REUSE PLAN FOR 95A PENDLETON HILL ROAD

NORTH STONINGTON
CONNECTICUT

Eastern Connecticut Environmental Review Team Report

October 1996

Site Plan

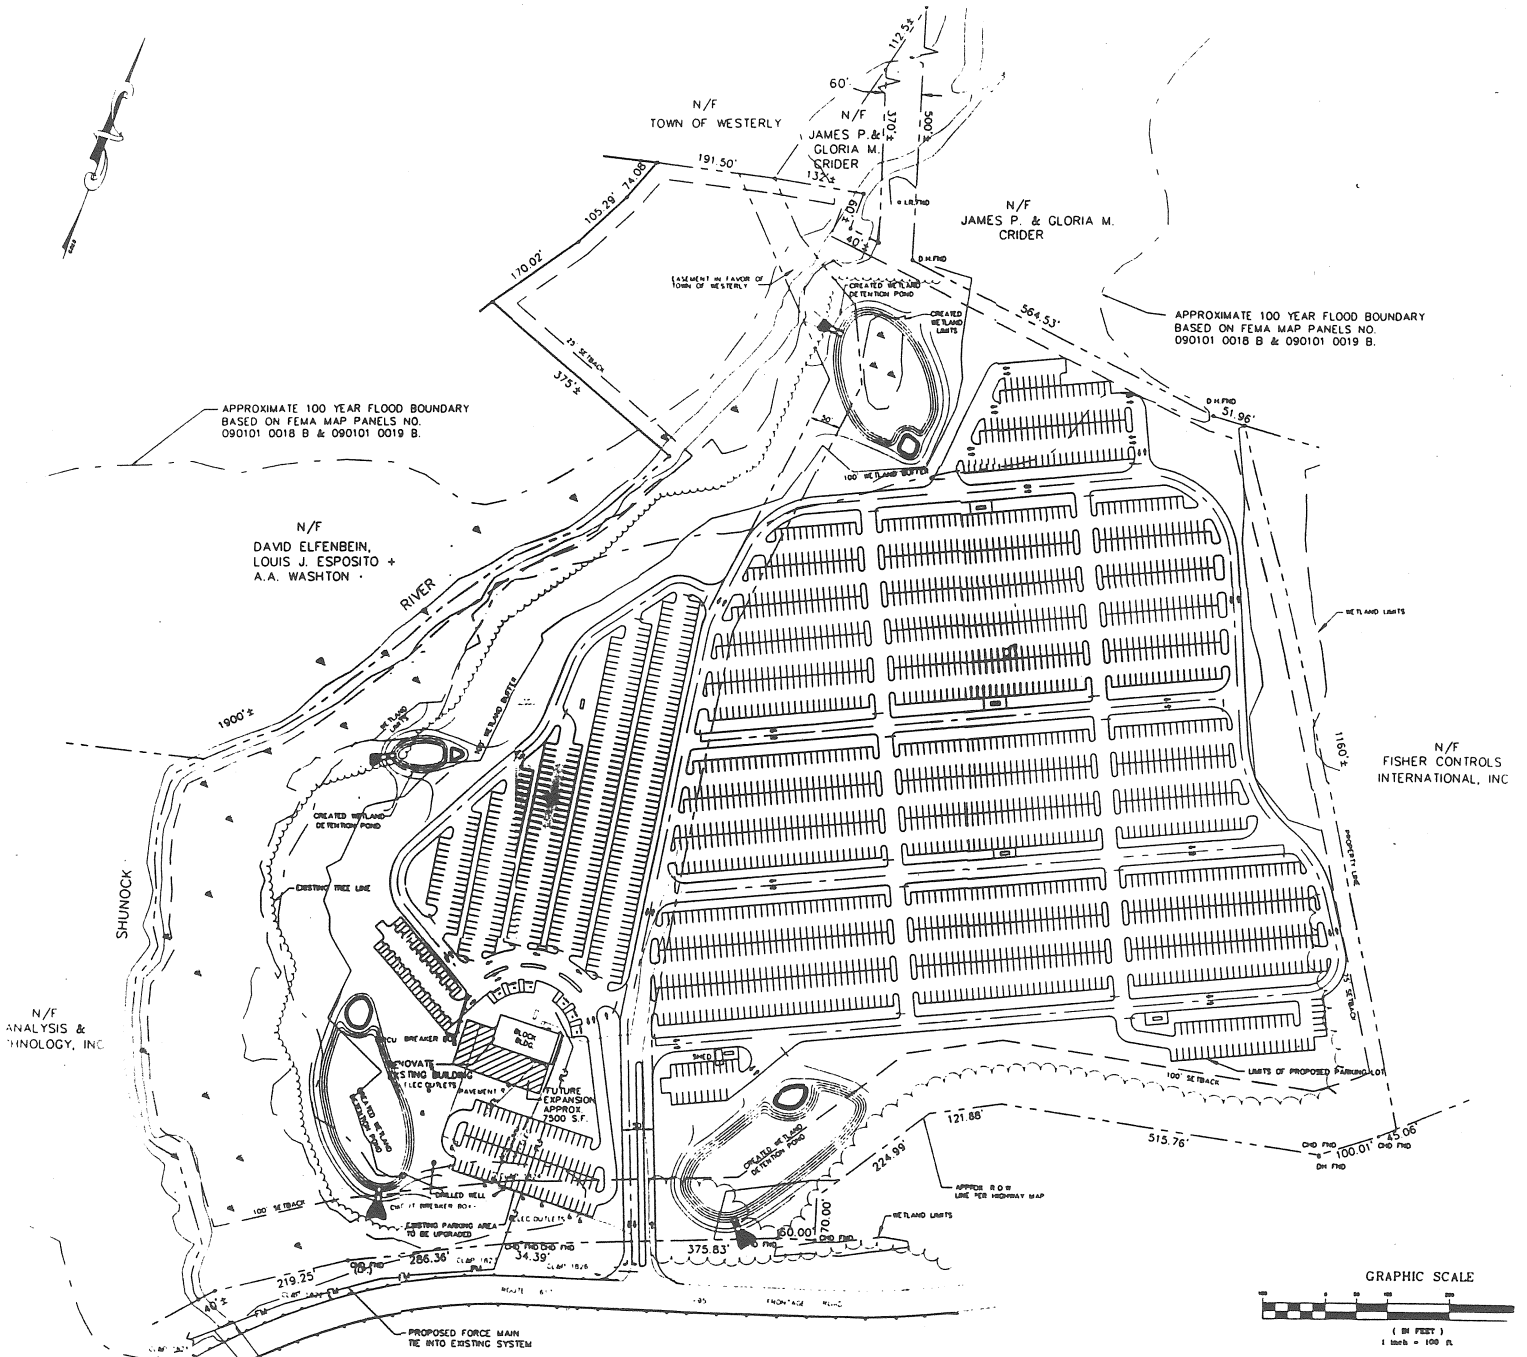
Maintenance of the stormwater management system is addressed by the applicant with item #15 on sheet 11 of 14, however it should also include maintenance of the detention pond plunge pools, ponds and pond outlets. Obviously, the success of this stormwater management plan is dependent on the effective operation of the created wetlands. Monitoring of these wetlands by a qualified wetland scientist should occur on a regular basis for at least three and preferably five years. Corrective measures that may be necessary to restore these wetlands to their intended condition and function may need to occur throughout their intended "life span." The maintenance plan can be enforced as an implicit or explicit condition of a permit issued based on this site plan. If a higher degree of enforcement is needed, the maintenance plan could be incorporated into a separate legal agreement of covenant entered into by the applicant and the Town of North Stonington. (Please also refer to the Stormwater Management section.)

Should the riparian zone be wider than shown on the site plan? Will the Russian olive that is currently growing within the proposed buffer area provide an adequate riparian zone?

Recommended riparian zone or corridor widths vary according to the purposes designated for that corridor. It has been shown that for most water quality issues a corridor 100 feet wide is sufficient. For the purpose of wildlife movement, a 200 foot corridor is more effective. According to the site plans, all parking lot construction is kept 100 feet from the wetland boundary and for

at least half the site, 200 feet from the Shunock River. The proposed basins will fall within the 100 foot buffer zone, however they could be viewed as habitat enhancement, not development per se, due to their created marsh habitats.

The measures outlined in the proposed erosion and sediment control plan (E&S plan) appear to be adequate except that the location and protection measures for temporary soil stockpile areas are not shown. Drainage outfalls should also be protected with a double row of silt fence. Any E&S plan is only as good as its installation and maintenance. These should be monitored carefully by on-site personnel as well as town and state inspectors. Changes that are inevitable in any construction project must also take the E&S plan into account. The project will be covered under the General Permit for the Discharge of Stormwater and Dewatering Wastewaters from Construction Activities and must also comply with the requirements of that permit. Town and DEP personnel may make inspections and require changes at any time to keep the site in compliance with town and state regulations.
